TO: Kevin Cricchio, Senior Planner
Skagit County Planning and Development Services

FROM: Alan Wald, Hydrogeologist
Facet, Inc.

RE: Lake Erie Pit Groundwater Evaluation.

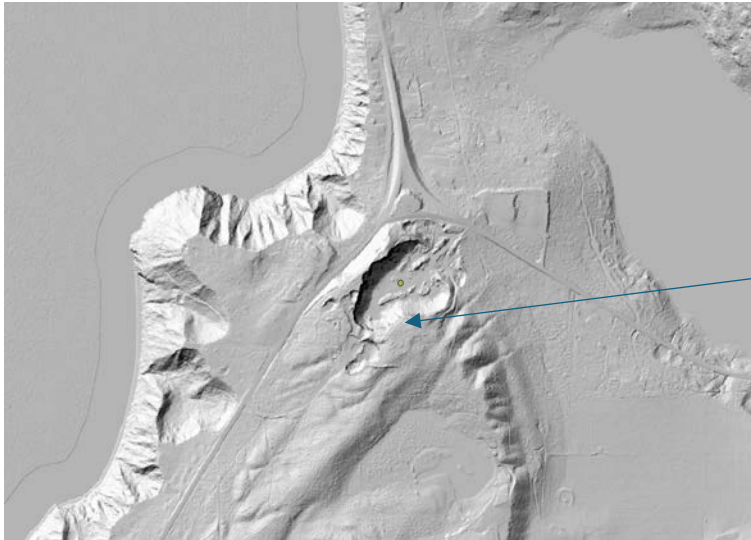
We note that residents on the coastal bluffs west of the proposed mine certainly are concerned about potential increases in bluff retreat rates and changes in bluff stability. Coastal bluffs from Biz Point to beyond Edith Point are mapped as geologically hazardous areas for good reason. The bluffs have been receding continuously for 6,000 years, retreating landward more than 740 feet since the increase in sea level following continental glaciation (Keuler, 1979). As shown in the LiDAR image (below), the coastal bluff landform includes steep slopes (some greater than 30%), high bluffs (greater than 300 ft), and numerous landslides resulting from coastal erosion and slope failures.

Most of the large slides visible in this image are more than 1,000 years old (Keuler, 1979). The small slides are typically non-hazardous slope readjustments due to local slumps, soil creep, and surface erosion. The estimated long-term bluff retreat rate is on the order of 2 to 4 cm/yr for 40 years prior to 1988 (Keuler, 1988). The area between Biz Point and Edith Point had 3 to 7 major slope failures in 20 years prior to 1988 (ibid).

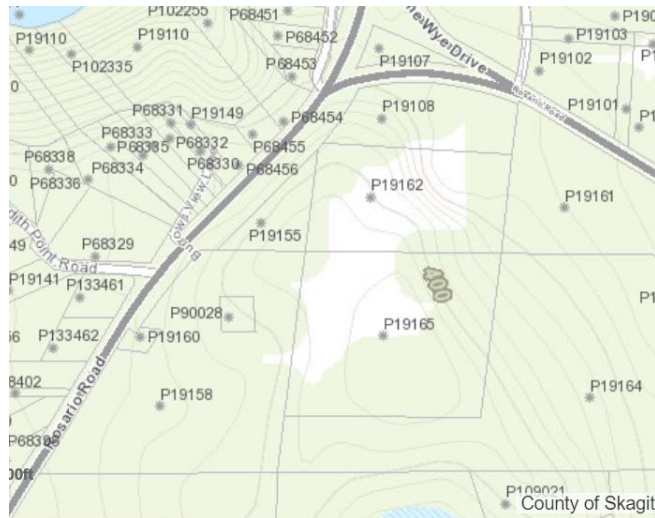
We note that the additional groundwater investigation and analyses presented in the NWGC report supports the conclusion that the risk of increased groundwater flow towards the springs is very small. Based on detailed information available in the studies to date, less than 10% of the mine area could contribute any additional flow towards the bluffs. It appears that any increase in groundwater flow towards the bluffs would originate in the western portions of parcels P19108, P19162, P19155, and P19158, shown in the Skagit County iMAP (below) and NWGC report, Figure 7.

A possible mitigation measure to reduce the small risk even further would be to increase the buffer width from the current 50 feet to 100 feet along the western boundary of these parcels. The remaining mining area clearly drains away from the bluffs and towards Lake Erie.
